**ADDENDUM #1**

**APPLIED ARTS & SCIENCES  
ROOF SCREEN PROJECT**

## ADDENDUM NO. 01

**TO THE CONTRACT DOCUMENTS FOR  
WEST VALLEY APPLIED ARTS & SCIENCES RENOVATION  
1400 Fruitvale Blvd, Saratoga CA 95070  
FOR THE  
WEST VALLEY MISSION COMMUNITY COLLEGE DISTRICT  
DSA A# 01-116396 – FILE NO. 43-C3**

Sketch	Revision
	<b>M-1</b>
Job. No. 12024.20	Description ADDENDUM 01: FLOOR PLAN UPDATE
Reference	
Date 5/24/17	
Scale 1/8" = 1'-0"

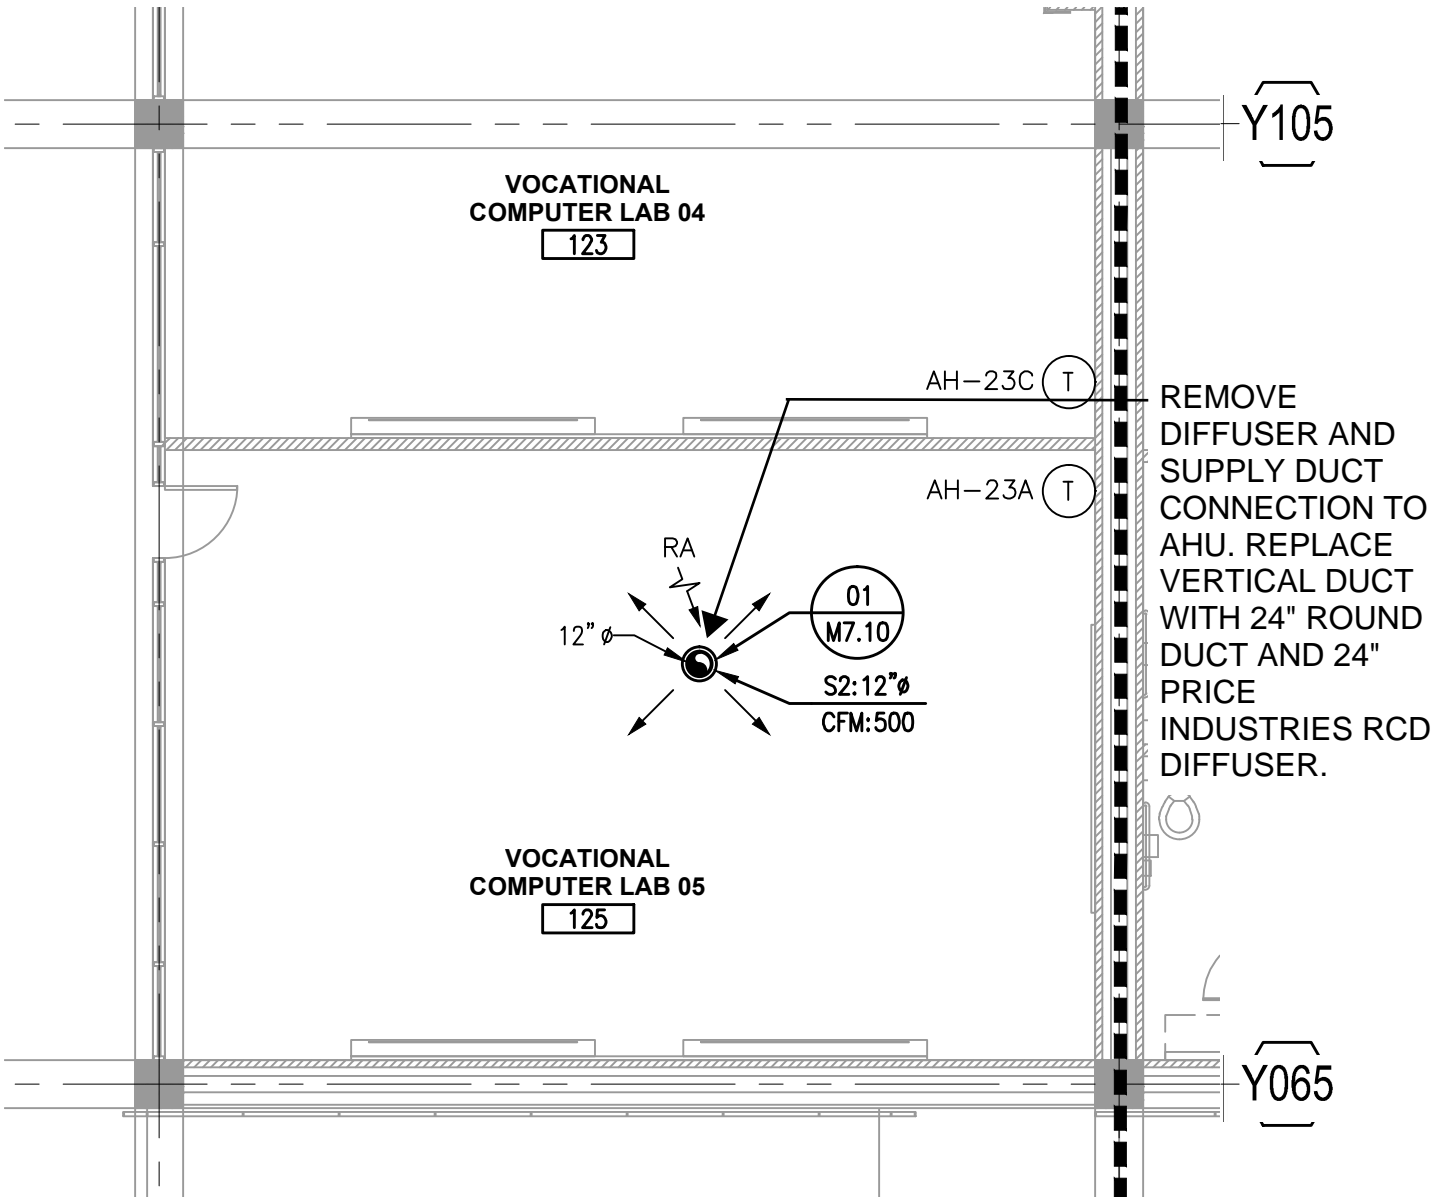
- ITEM NO. 01** Sketch M-1  
Refer to newly issued sketch M-1. Contractor to remove and replace existing supply air duct and diffuser in Classroom 125, served by AH-23A, with new 24" supply duct and new 24" Price Industries Model RCD supply air diffuser, similar to installation in Classroom 123.
- ITEM NO. 02** Sketch M-2  
Refer to newly issued sketch M-2. Contractor to reprogram supply fan variable frequency drive (VFD) for AH-23A. Program maximum VFD speed to 60 HZ.
- ITEM NO. 02** Adjust EMS set points for AH-23A  
Coordinate with college facilities staff to establish fan set points for AH-23A via the existing building EMS. Recommended set points are below. Revise set points as required based on acoustics and thermal performance.
- Supply Fan Low Speed – 80%
  - Supply Fan High Speed – 100%
  - Relief Fan Low Speed – 0%
  - Relief Fan High Speed – 80%
